**VALUE ENGINEERING CHANGE PROPOSAL
MISSOURI DEPARTMENT OF TRANSPORTATION**

Contract ID 110218-401 **Job No.** J4I1121B

RE: Proj. #J411121B
Route Front Street & I-435
Jackson County, Mo

_____ Use Armormax engineered slope reinforcement system in lieu of rock fill for ramp widening.

I-435 SHOULDER IMPROVEMENTS

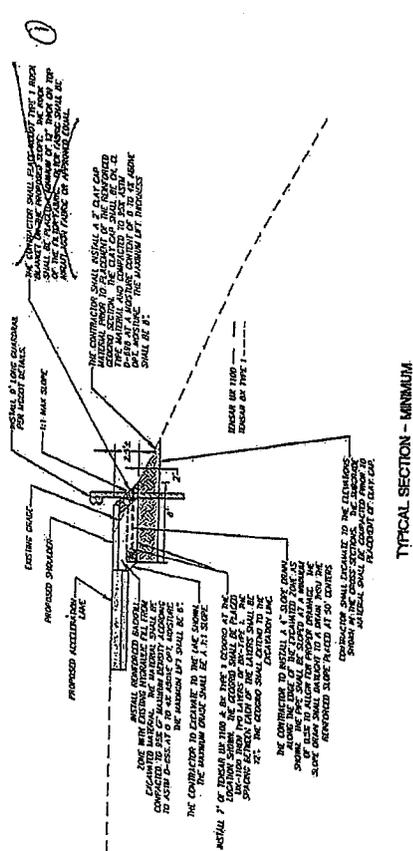
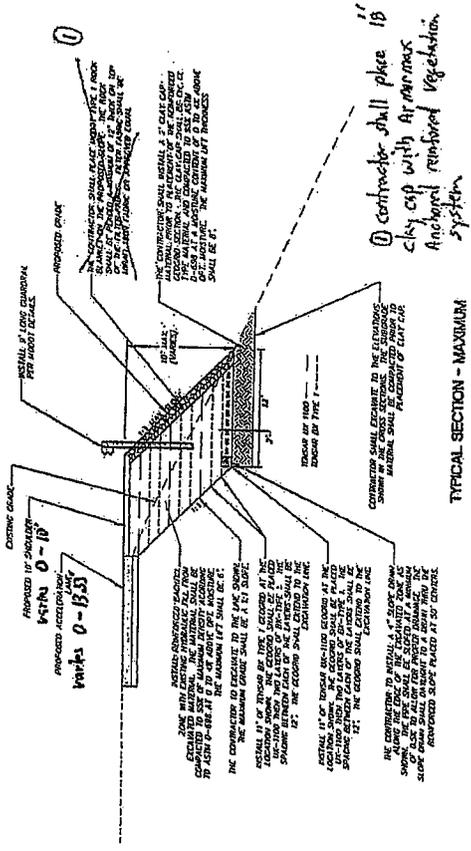
Attached is information for the Armormax anchored reinforced vegetation system. Also attached is a revised typical section showing the roadway and shoulder widths, the deletion of type 1 rock blanket, and the addition of the Armormax slope protection. If this proposal is acceptable, we will provide new typical section incorporating all changes and will provide

I-435 SHOULDER IMPROVEMENTS CROSS SECTIONS KANSAS CITY, MISSOURI

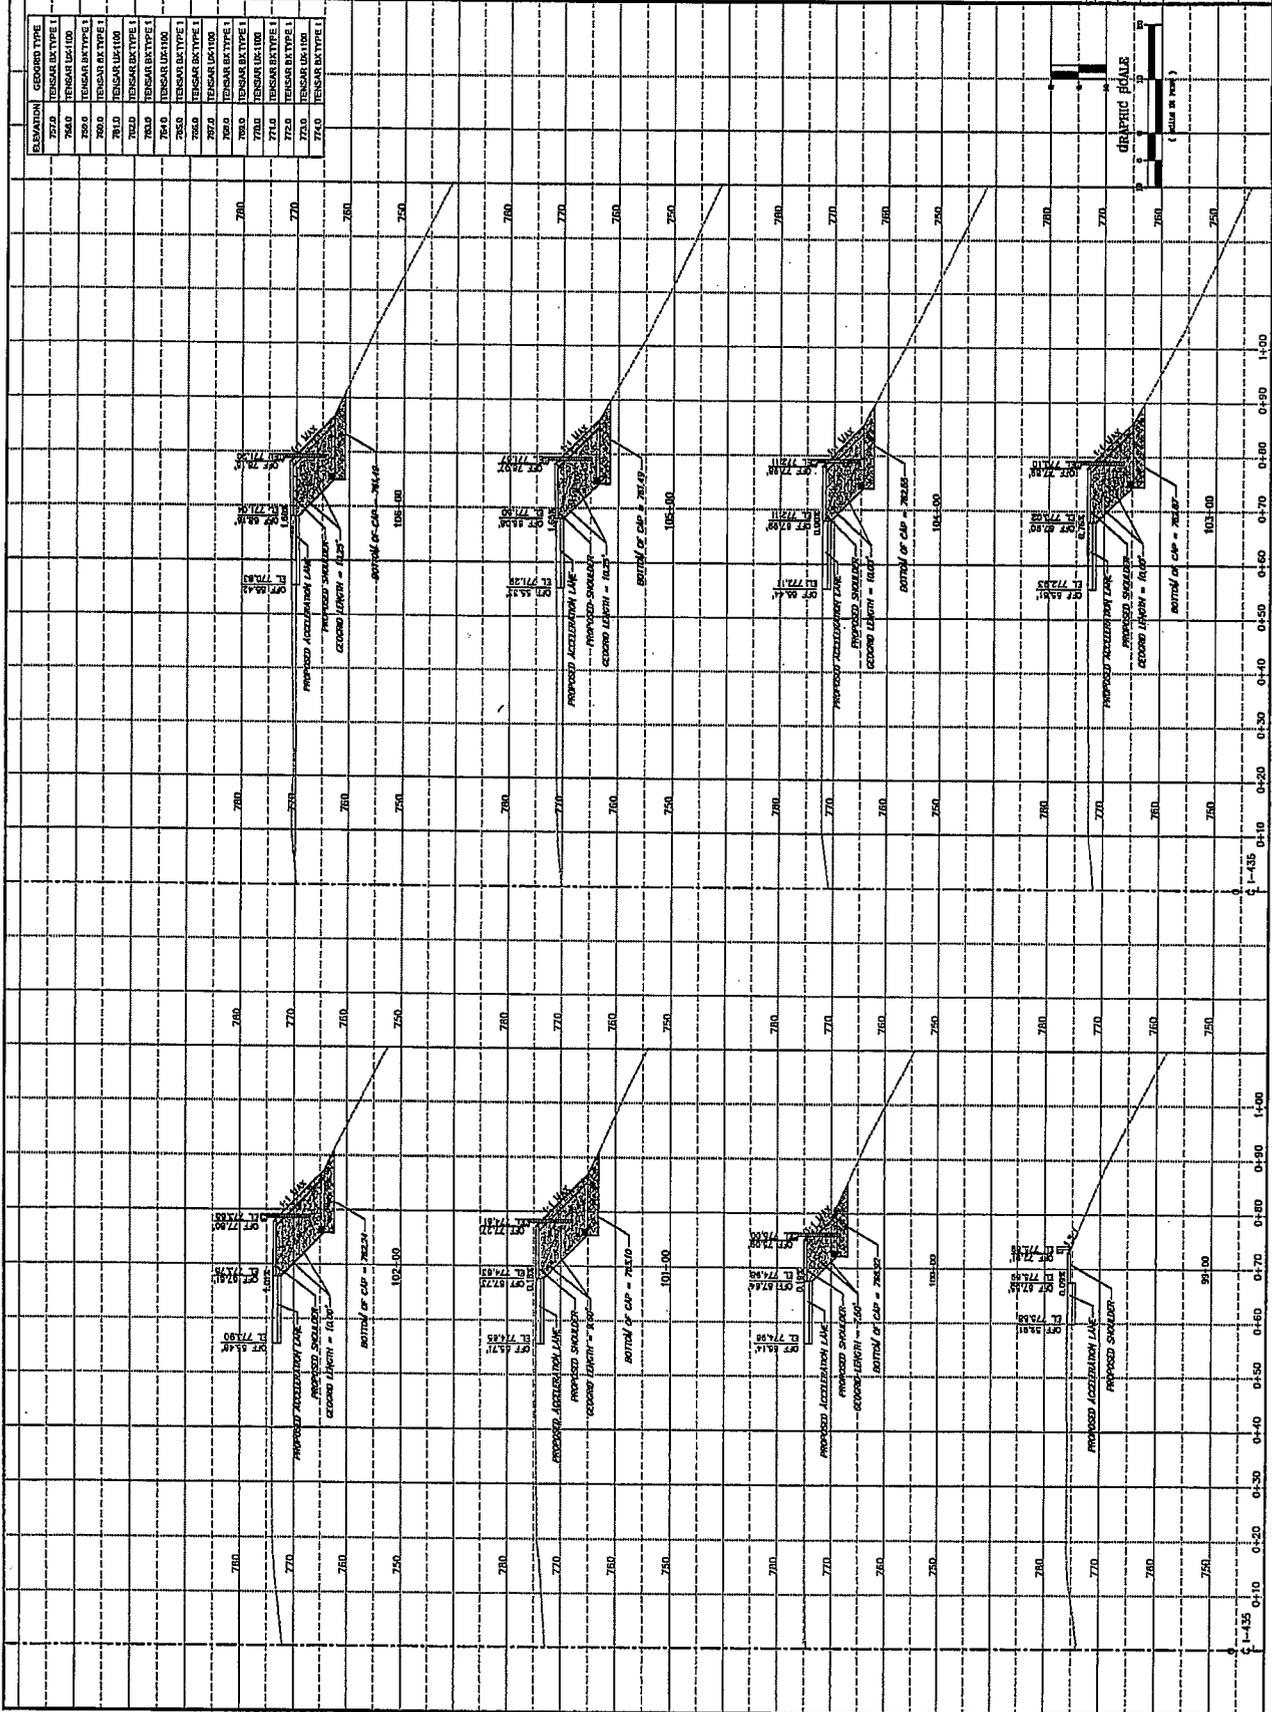
Sheet 2 - Cross Sections (Sta 99+00 to 106+00)

I-435 SHOULDER IMPROVEMENTS CROSS SECTIONS KANSAS CITY, MISSOURI

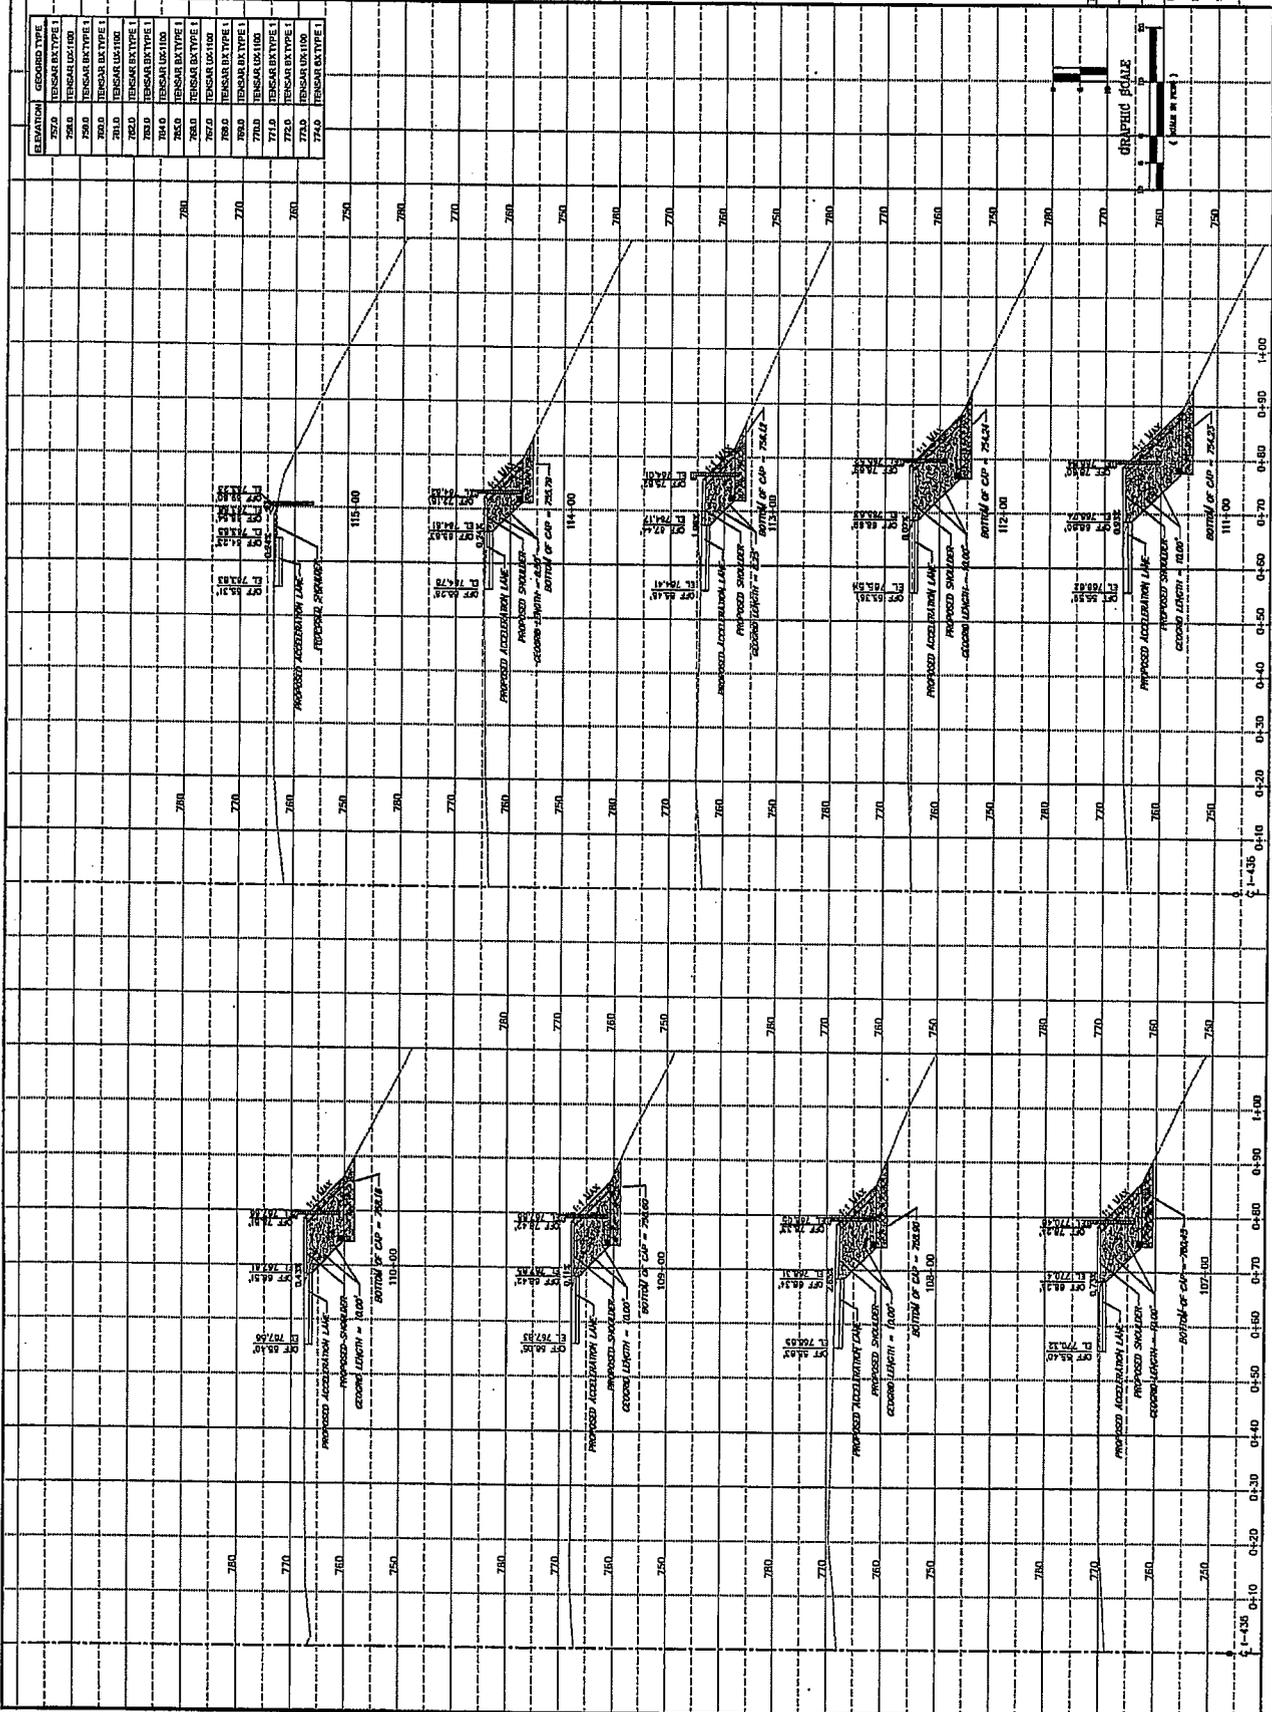
Sheet 3 - Cross Sections (Sta. 107+00 to 115+00)
